**BROWNS FERRY NUCLEAR PLANT (BFN) – UNITS 2 AND 3 – TECHNICAL SPECIFICATIONS (TS) CHANGE TS-418 – EXTENDED POWER UPRATE (EPU) – PARTIAL RESPONSE TO ROUND 18 REQUEST FOR ADDITIONAL INFORMATION (RAI) (TAC NOS. MD5263 AND MD5264)**

On July 17, 2008, the NRC staff issued a Round 18 RAI (ML081700102) regarding AREVA fuel methods used in support of Units 2 and 3 EPU. Round 18 consists of 32 additional RAI questions, SRXB-91 through SRXB-122. TVA agreed to provide a response to RAI Round 18 by September 15, 2008. To facilitate the processing of TS-418, TVA requested a meeting with NRC to review the draft responses to SRXB-91 through SRXB-116 and to discuss the TVA approach to responding to SRXB-117 through SRXB-122. That meeting was held on August 7, 2008, and included a presentation by AREVA on behalf of TVA of the draft responses to RAIs SRXB-91 through 116 and a general discussion of the approach to SRXB-118 through 122. Time did not permit allow the discussion of SRXB-117; however, a teleconference with NRC on SRXB-117 has been requested. This submittal provides a partial response to Round 18, namely to SRXB-92, 93, 95, 96, 97, 99, 100, and 102 through 116. The remainder of the Roun

Figure SRXB-93.1 Comparison of Ohkawa-Lahey Void-Quality Correlation to Various Void Fraction Data

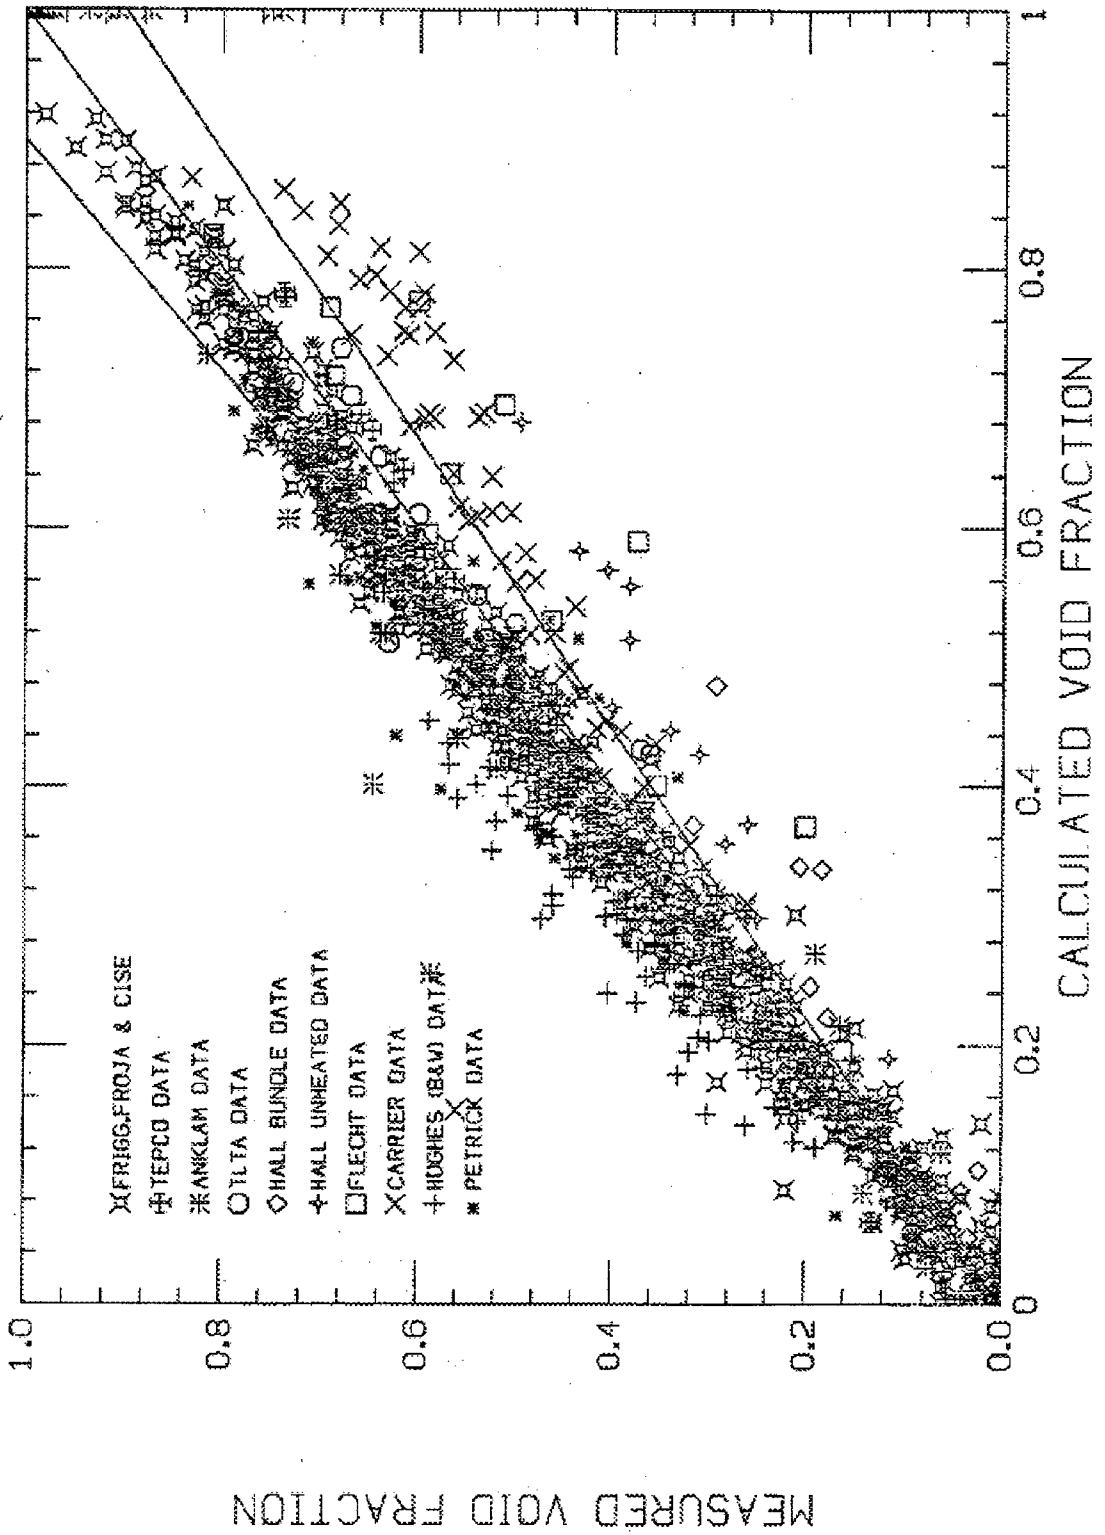
Provide justification for the application of the Ohkawa-Lahey void-quality correlation to pressures above 6.9 MPa.

A measured versus predicted plot of void fraction containing all the data analyzed by the authors is reproduced in Figure SRXB-93.1. The data with hydraulic diameter in excess

of 0.5 ft. (0.152 m) are indicated as "CARRIER DATA" and "HUGHES (B&W) DATA" in this figure. The statistical results and conclusions reported by the authors for geometries similar to BWR rod bundles are consistent with the AREVA assessment that was summarized in the response to NRC RAI SRXB-A.35. One set of data in this population extended above a pressure of [ ], which was reported by Petrick (Reference SRXB-93.2). The Petrick data provided experimental results for co-current down-flow at 600, 1000, and 1500 psia (4.1, 6.9, and 10.3 MPa) in a 1.939 inch (0.049 m) diameter tube.

The mean and standard deviation of the absolute error (measured-predicted void fraction) for the Ohkawa-Lahey void-quality correlation were reported as 0.038 and 0.050, respectively for the 1500 psia (10.3 MPa) data set in Reference SRXB-93.1. The reasonable agreement between the data and Ohkawa-Lahey predictions shows the extensibility of the correlation to pressures and flow conditions outside the range experienced in BWR rod bundles under typical operating and transient conditions including its extensibility to pressures up to 1500 psia (10.3 MPa).

In summary, the Ohkawa-Lahey void-quality correlation is justified for use above 1000 psia (6.9 MPa) based on validation of the correlation to a broad range of geometries and flow conditions including pressures up to 1500 psia (10.3 MPa).

**Figure SRXB-96.1 SRV Flow During ATWS Overpressurization**

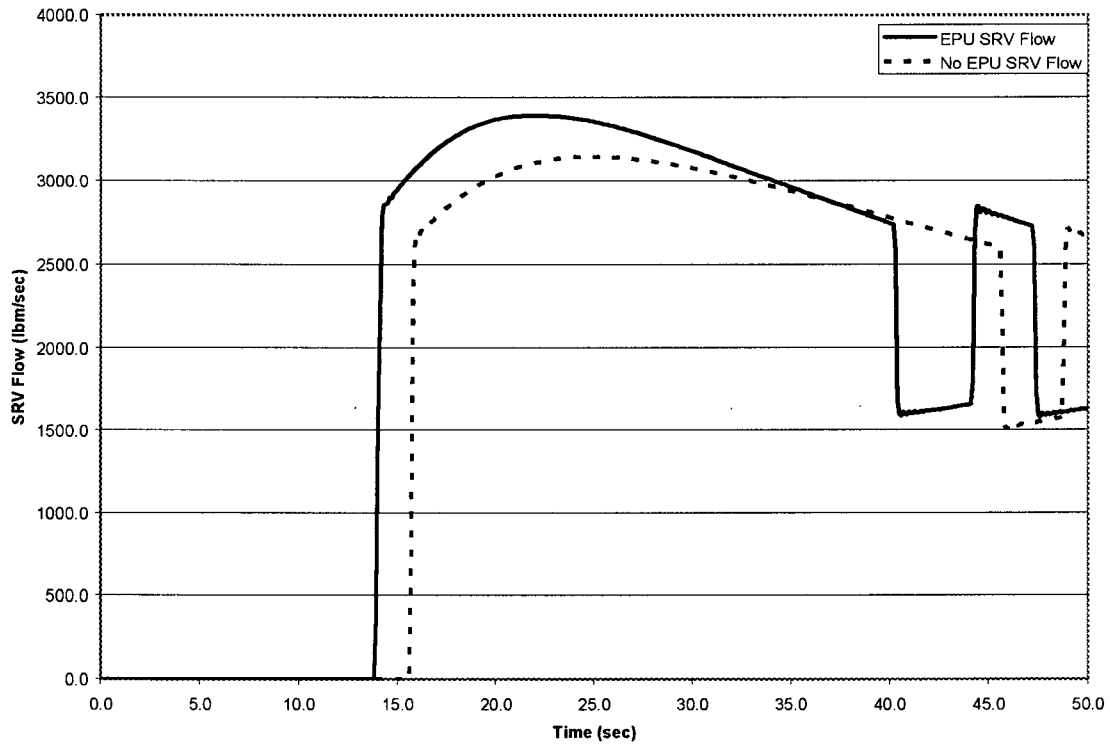
Provide a plot of the total safety relief valve (SRV) flow during ATWS overpressurization for EPU and pre-EPU conditions.

A plot of total SRV flow during an ATWS overpressurization is provided below for EPU and non-EPU operation of a Browns Ferry Unit 3 Cycle 14 design.
